PART OF THE SOUTHEAST 1/4 OF SECTION 11, TOWNSHIP 15 SOUTH, RANGE 66
 WEST OF THE SIXTH PRINCIPAL MERIDIAN,
 COUNTY OF EL PASO, STATE OF COLORADO
MAJOR SITE DEVELOPMENT PLAN

2232 - EL PASO, COLORADO
 SECURITY BLVD. AND MAIN ST.
GRADING PLAN

MAJOR SITE DEVELOPMENT PLAN

COVER SHEET

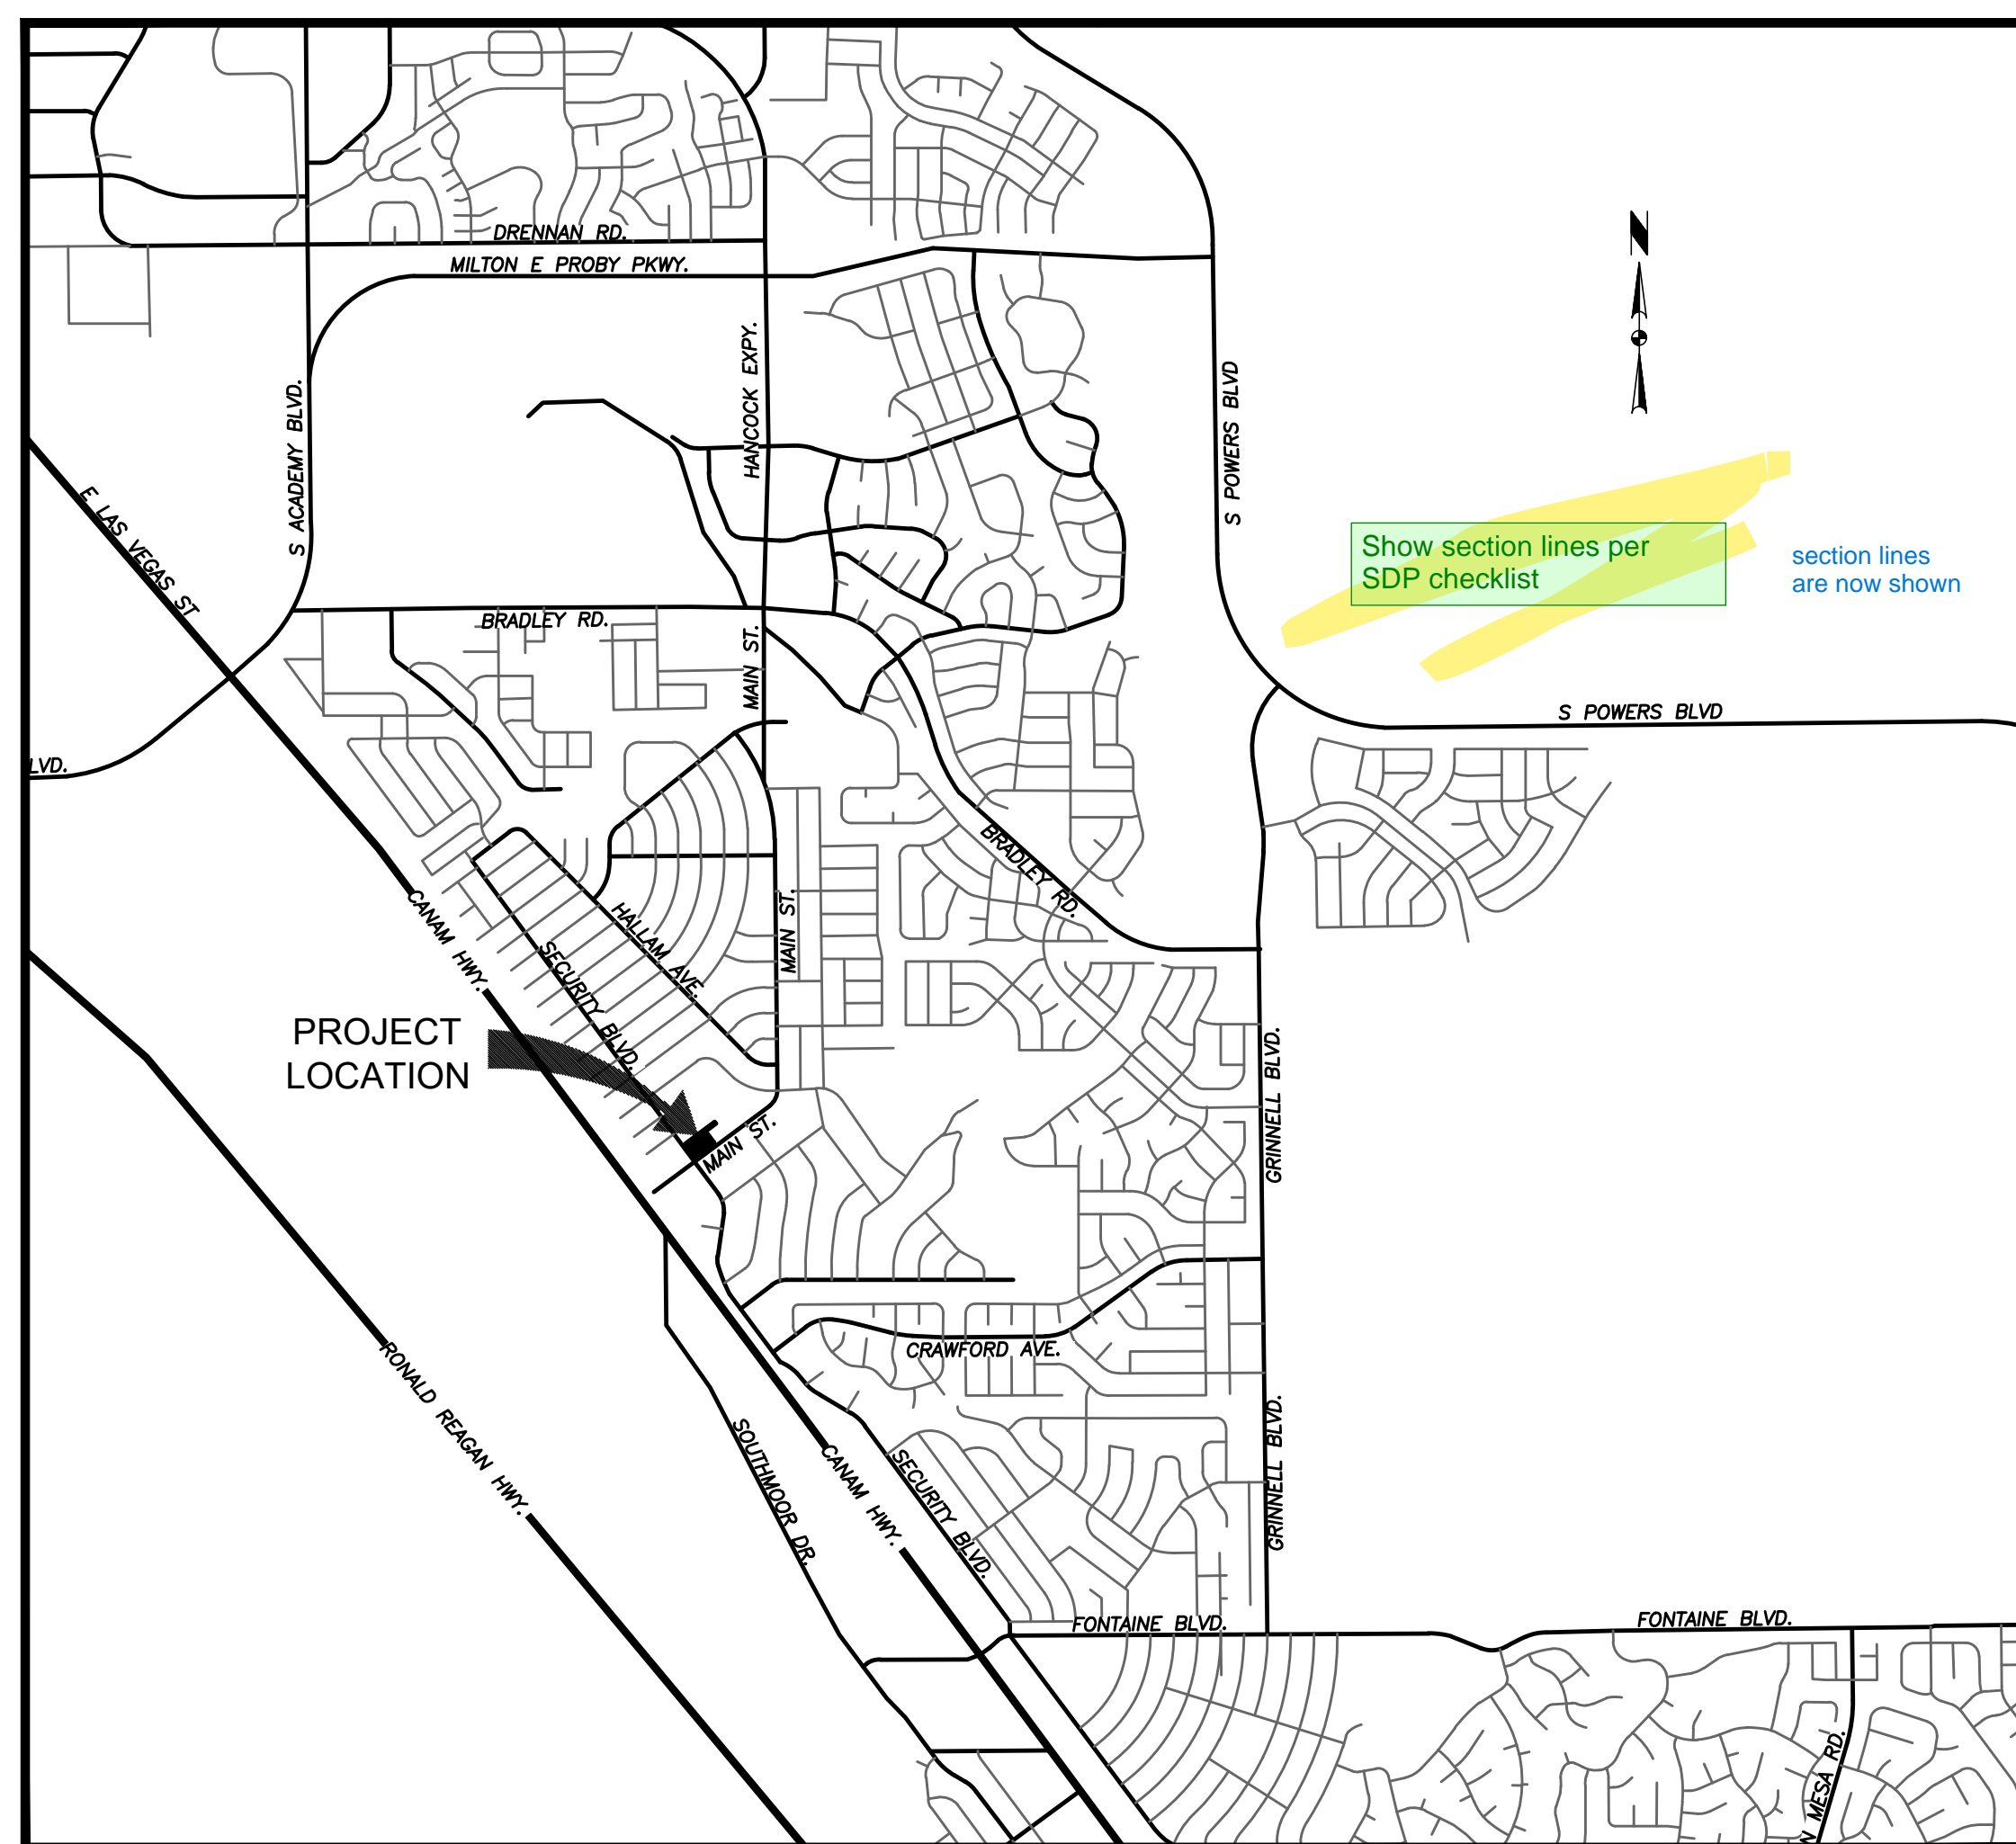
Please add PCD File No. PPR-2225

ADDED PCD FILE NO. TO TITLEBLOCK TO SHOW UP ON ALL SHEETS

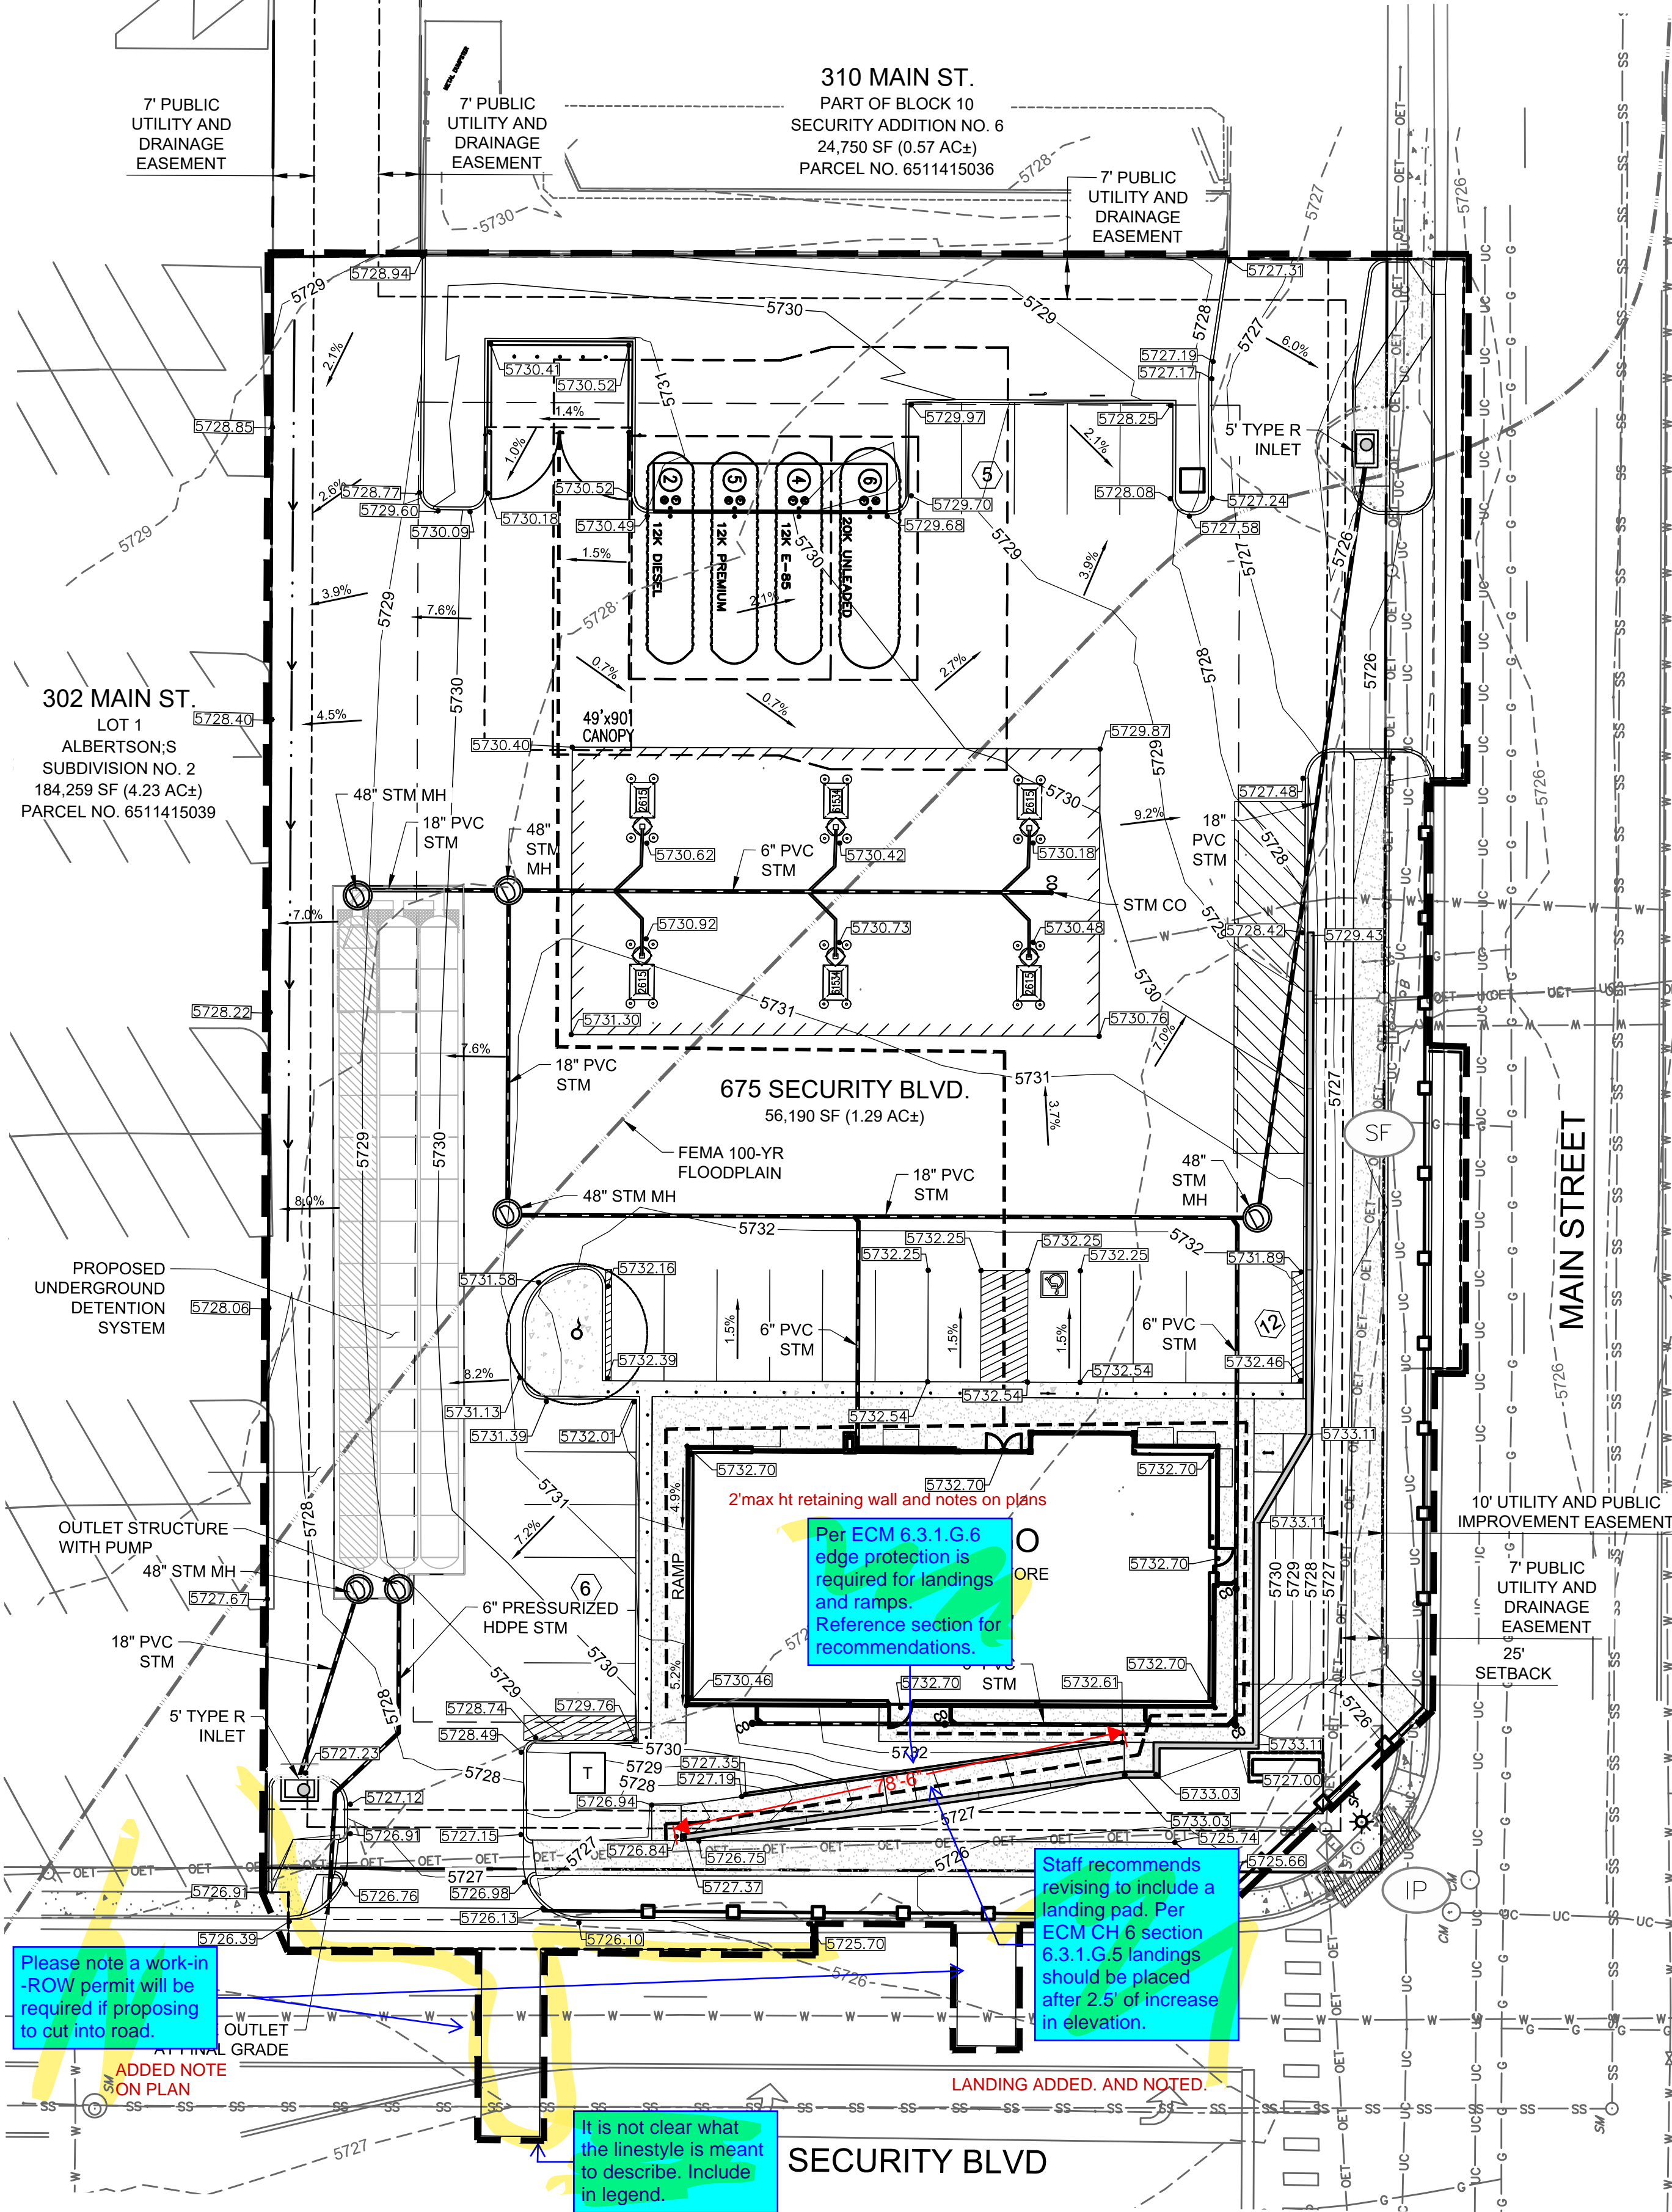
Please remove signature blocks. The Engineering Manager will only approve engineering documents. Any plans related to grading should be included in the grading and erosion control plan.

added linetype to legend for clarification

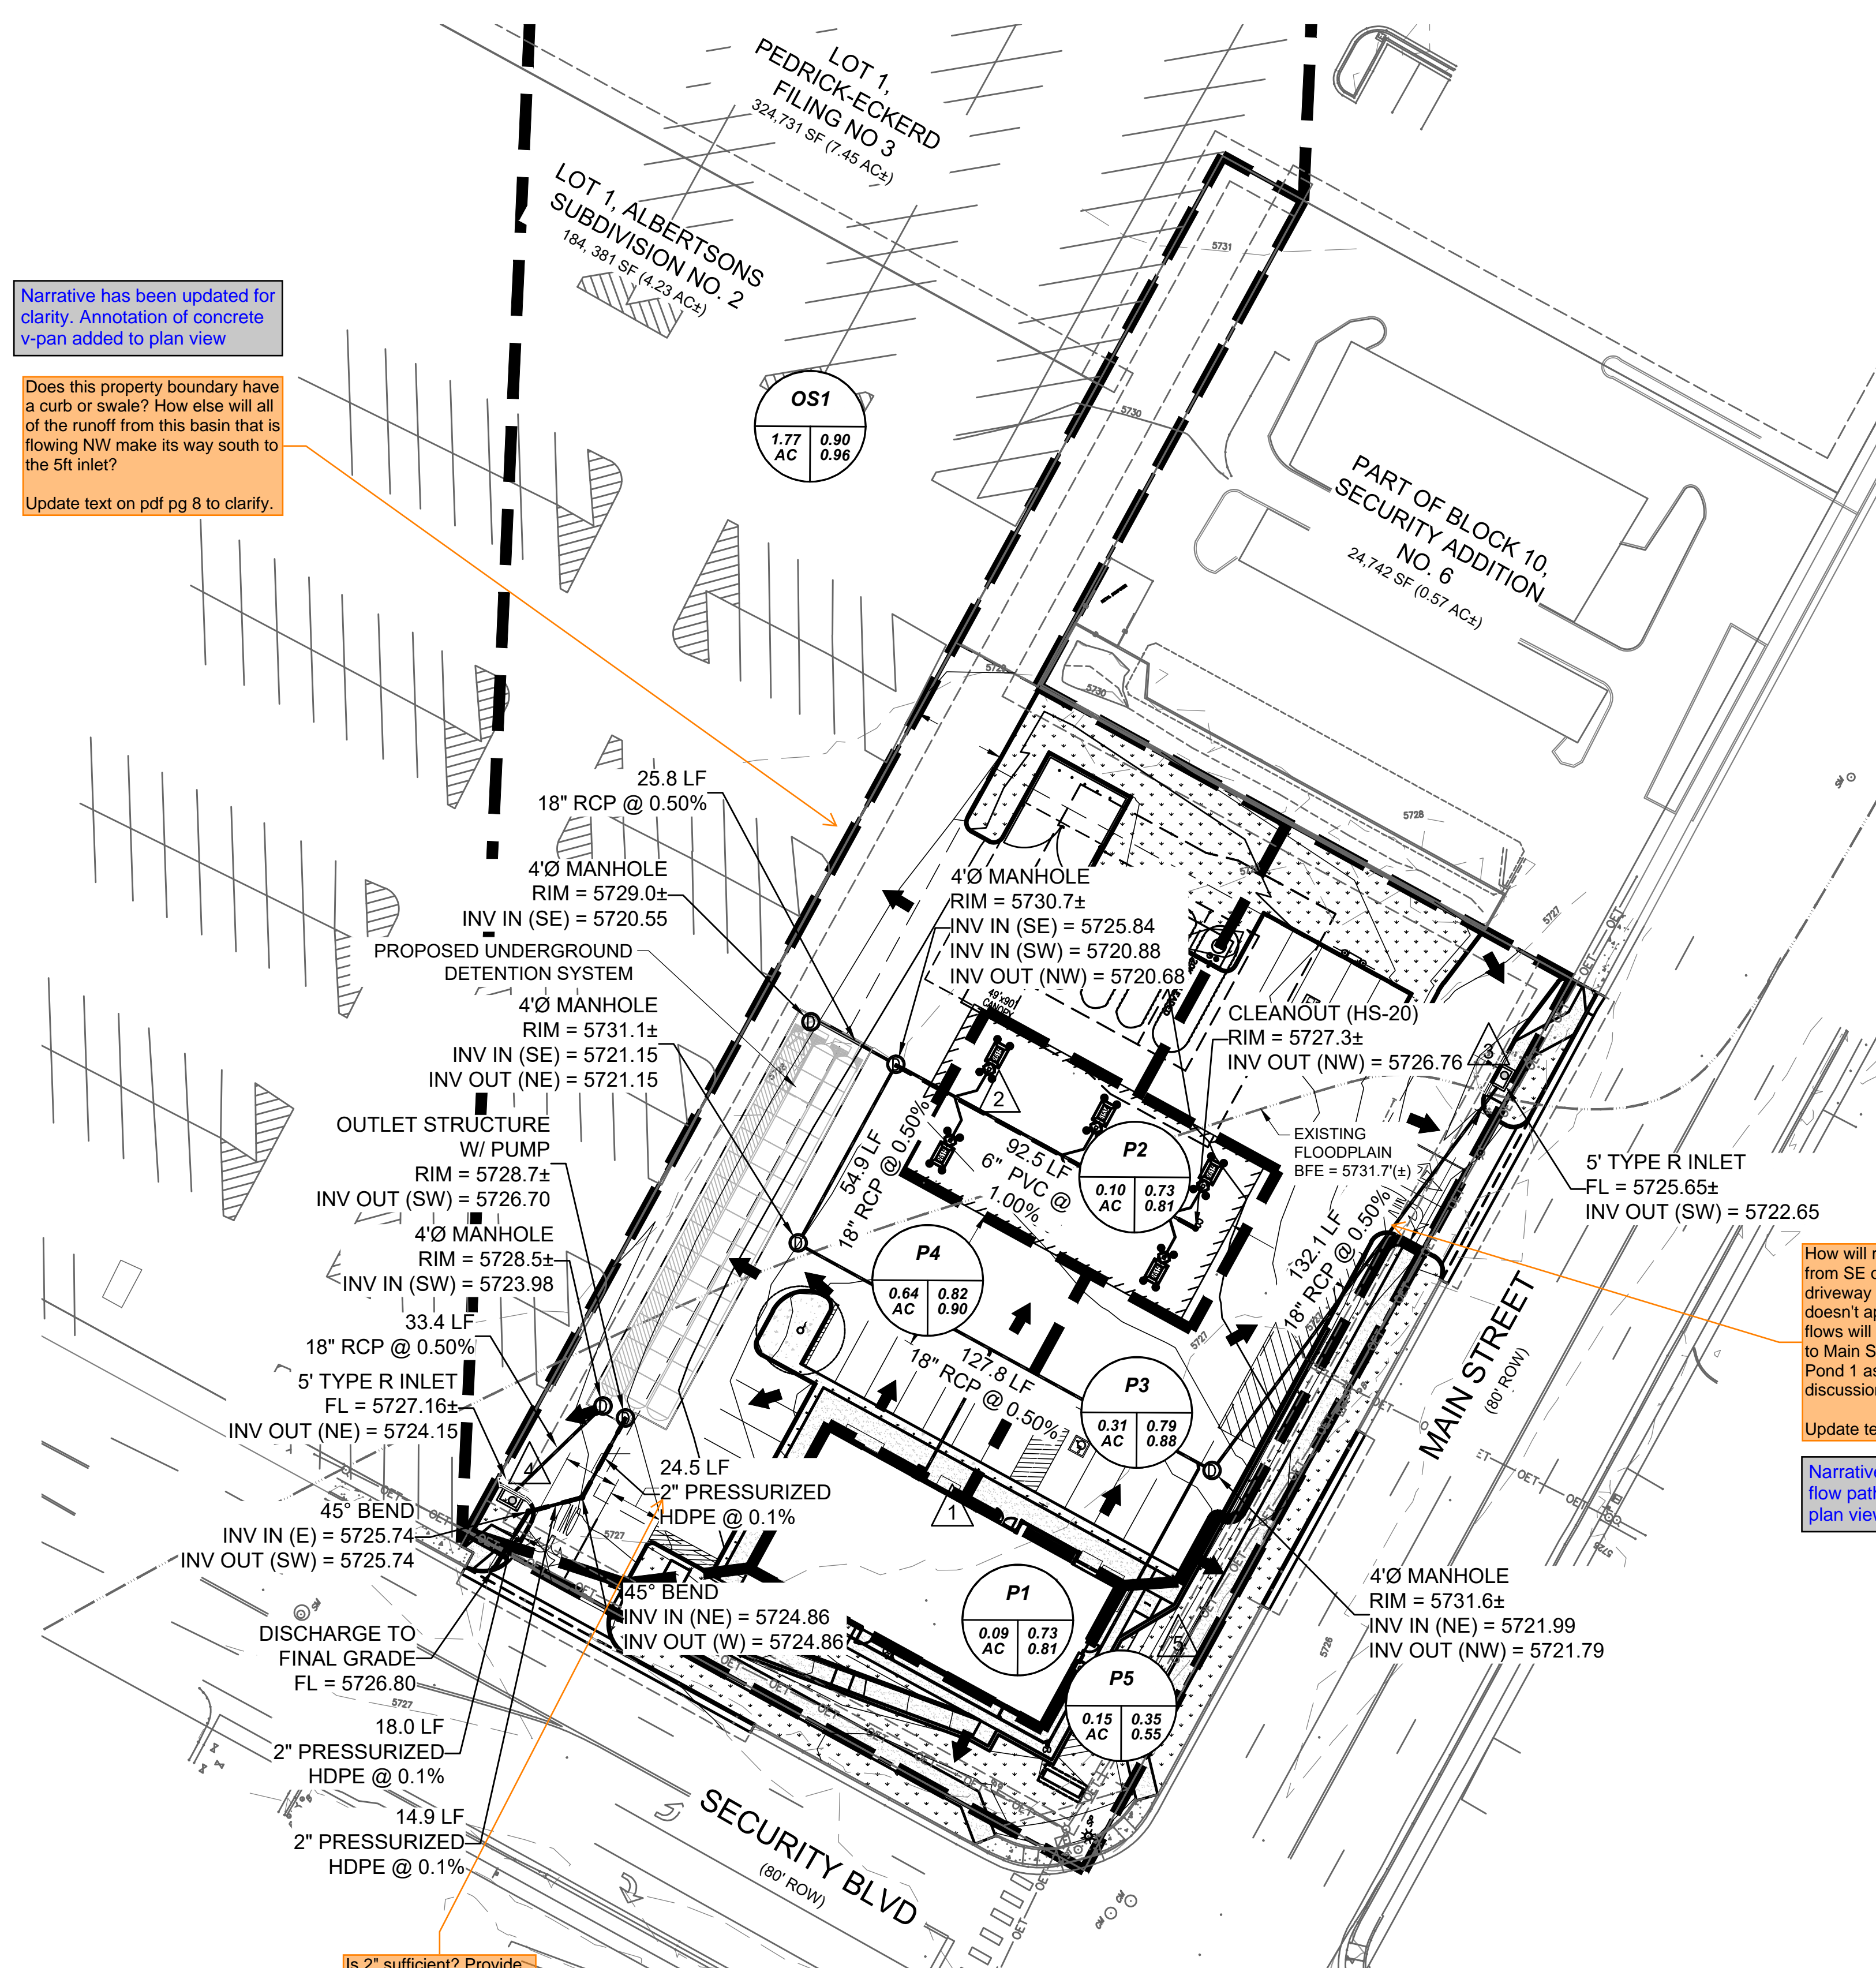
Does this property boundary have a curb or swale? How else will all of the runoff from this basin that is flowing NW make its way south to the 5ft inlet?
 Update text on pdf pg 8 to clarify.

Narrative has been updated for clarity. Annotation of concrete v-pan added to plan view
